LINCOLN-LANCASTER COUNTY HEALTH DEPARTMENT

INDIVIDUAL SEWAGE SYSTEM CONSTRUCTION — TYPE OF PERMIT

FORM 20103-0477
REQUEST FOR SITE CLEARANCE AND PERMIT
FOR INDIVIDUAL SEWAGE DISPOSAL SYSTEM
City Ordinance No. 9150 ☐
County Resolution No. 2832 ☒

REAL ESTATE TRANSFER/LOAN APPROVAL FORM

AS BUILT DRAWING OF SYSTEM

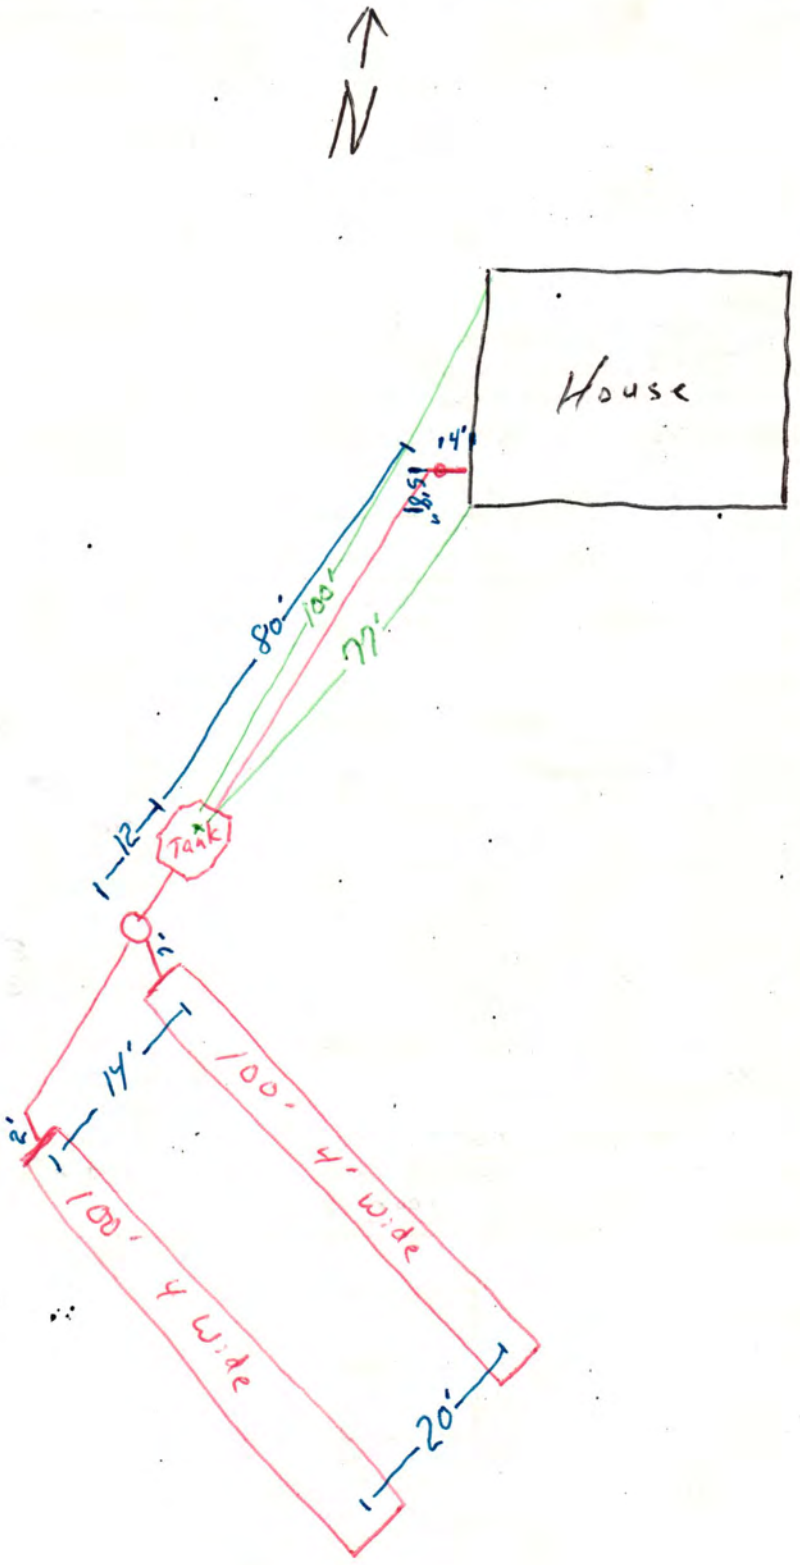
Comments: IF THE SEPTIC TANK HAS NOT BEEN PUMPED RECENTLY IT SHOULD BE CHECKED TO SEE IF IT IS NEEDED. WESTERN MOST LATERAL APPEARS TO BE GETTING MORE WATER THAN THE EASTERN ONE. MIGHT BE WISE TO SEE IF THE DISTRIBUTION HAS BECOME TIPPED. See Attached Letter ☐
